Project	IEEE 802.16 Broadband Wireless Access Working Group < http://ieee802.org/16 >	
Title	Ping Pong Call Resuming Procedure during HO	
Date Submitted	[2004-03-11]	
Source(s)	Hyunjeong Kang Changhoi Koo Jungje Son Sohyun Kim Samsung Elec. 416, Maetan-3dong, Youngtong-gu Suwon-si, Gyeonggi-do Korea	Voice: +82-31-279-5091 Fax: +82-31-279-5130 hyunjeong.kang@samsung.com chkoo@samsung.com jungje.son@samsung.com binde.kim@samsung.com
Re:	This contribution is for call for contribution IEEEP802.16e/D1-2004	
Abstract	This contribution proposes the fast call resuming procedures for ping pong experienced MSS during handover.	
Purpose	Propose the ping pong call resuming procedures for the IEEE802.16e Handoff Ad hoc group	
Notice	This document has been prepared to assist IEEE 802.16. It is offered as a basis for discussion and is not binding on the contributing individual(s) or organization(s). The material in this document is subject to change in form and content after further study. The contributor(s) reserve(s) the right to add, amend or withdraw material contained herein.

Ping Pong Call Resuming Procedures during HO

Hyunjeong Kang, Changhoi Koo, Jungje Son, Sohyun Kim

Figure 1 Call Resuming procedure for ping poned MSS

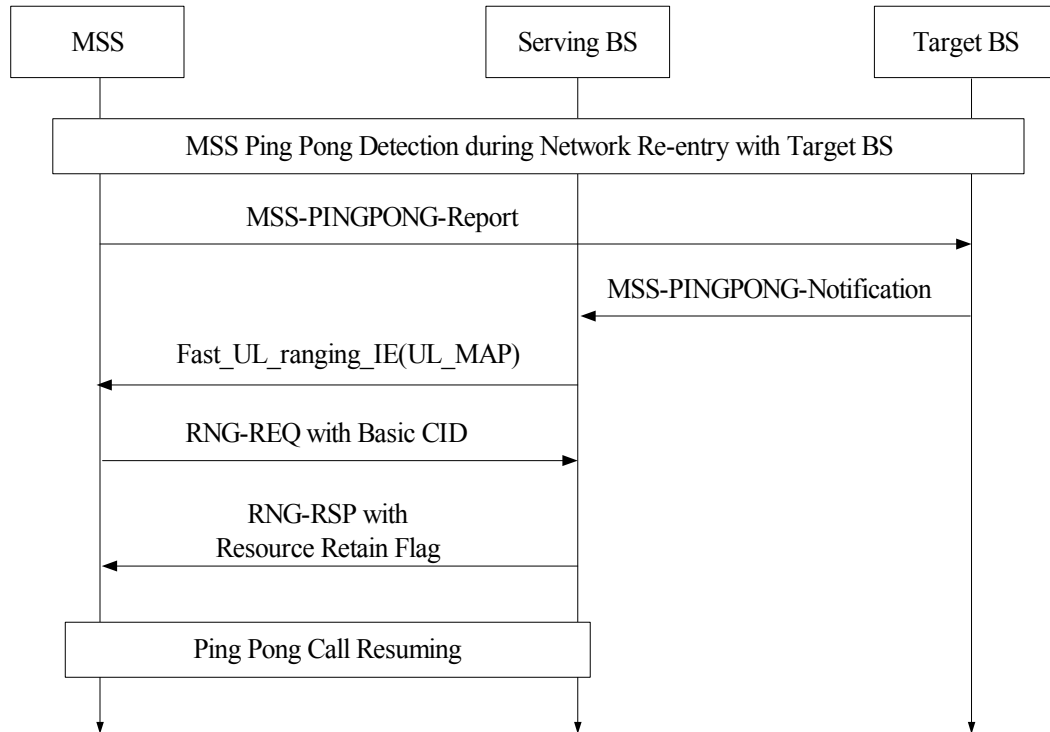
For the purpose, we propose two messages: one is MSS_PINGPONG_Report message for reporting MSS's ping pong experience to the Target BS and the other is MSS_PINGPONG_Notification message for also notifying the ping pong situation to the Serving BS. In the case of detecting MSS's ping pong by the ping pong notification message, the serving BS also allocates non-contention based ranging time offset to the MSS. This allocated non-contention based ranging opportunity can give the ping pong experienced MSS's call a priority to perform quicker call recovery than other normal calls. Therefore using the allocated non-contention based ranging time offset, the returning ping pong-experienced MSS performs the initial ranging for network re-entry with the Serving BS. For assuring the Serving BS of the MSS's returning by ping pong, the MSS can also include the previous Basic CID allocated from the Serving BS in the initial ranging request message. Upon receiving the ranging request with Basic CID, the Serving BS sends initial ranging response message with setting a flag whether the Serving BS retains the connection information of the MSS. If the Serving BS retains the MSS's connection information, the MSS and the Serving BS can quickly resume normal communication using the retained connection information without performing the complex network re-entry procedures for reestablishing the connection, except ranging. The example of fast call resuming procedures for the ping pong experienced MSS is depicted in Figure 1.
